APPLICATION NO.	FILING DATE	FIRST NAMED INVENTOR	ATTORNEY DOCKET NO.	CONFIRMATION NO.
10/681,567	10/08/2003	Motoyoshi Murakami	MTS-3473US	7770
23122	7590	12/21/2005	EXAMINER	
RATNERPRESTIA P O BOX 980 VALLEY FORGE, PA 19482-0980			BERNATZ, KEVIN M	
			ART UNIT	PAPER NUMBER
			1773	
DATE MAILED: 12/21/2005

Office Action Summary

Figure 1: Illustration of the recording layer of Kirino et al.

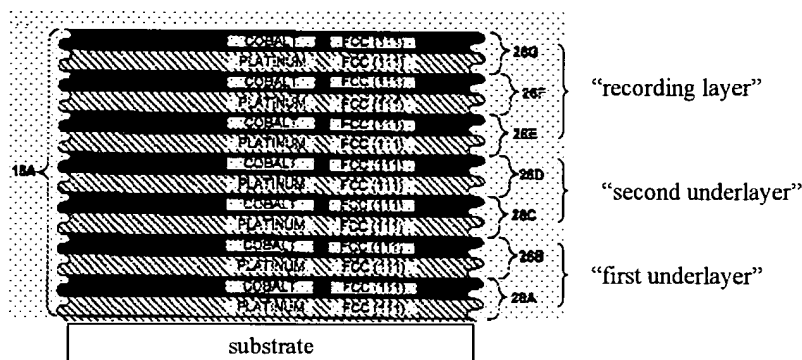
Kirino et al. ('154 A1) is relied upon as described above, except that the first underlayer, second underlayer and recording layer are all interpreted to be part of the superlattice structure as illustrated in Figure I below.

Kirino et al. ('154 A1) fail to disclose forming the first underlayer, second underlayer and recording layer of rare earth-transition metal (RE-TM) alloys.

However, Kirino et al. ('400) teach that MO recording media can be formed by using a recording layer possessing a multilayer structure similar to that used in Kirino et al. ('154 A1) wherein RE-TM layers are alternately laminated, wherein such a layer possesses improved MO effects and improved perpendicular anisotropy (*col. 2, line 66 bridging col. 4, line 56 and examples; especially col. 4, lines 48 – 56*).

It would therefore have been obvious to one of ordinary skill in the art at the time of the applicant's invention to modify the device of Kirino et al. ('154 A1) to use a structure meeting applicants' claimed limitations as taught by Kirino et al. ('400) since such a structure possesses improved MO effects and improved perpendicular anisotropy.
